# VEHICLE RECALL

**G-01516  
JUNE 2003**

**SUBJECT: NONCOMPLIANCE RECALL (U.S., EXPORT)  
Windshield Washer Pump Fuse on 4000 Series built  
10/24/2000 through 10/15/2001**

**Figure 1**

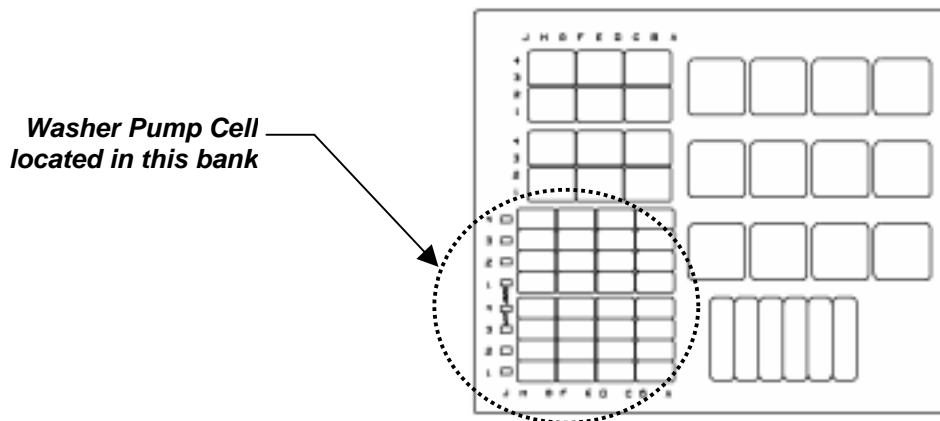
The 5-ampere windshield washer pump fuse, located in the Power Distribution Center, will fail under certain test conditions that render the washer system inoperable. A failure of the windshield washer system is a violation of Federal Motor Vehicle Safety Standard (FMVSS) 104 Section 3.2.

- B. Locate cell labeled, "5A WASHER PUMP," in the lower left bank of cells (see figure 1).
- If the washer pump cell indicates, "10A WASHER PUMP," this truck does **NOT** require this recall.
  - If the washer pump cell indicates, "5A WASHER PUMP," then continue to letter C.

- C. Thoroughly clean and dry the area in and around the, "5A WASHER PUMP," cell so the new label will adhere properly.
- D. Place the new label over the, "5A WASHER PUMP," cell so it now indicates, "10A WASHER PUMP."
- E. Locate and remove the 5-ampere washer pump fuse in the PDC. Replace with a 10-ampere fuse.
- F. Reinstall PDC lid.
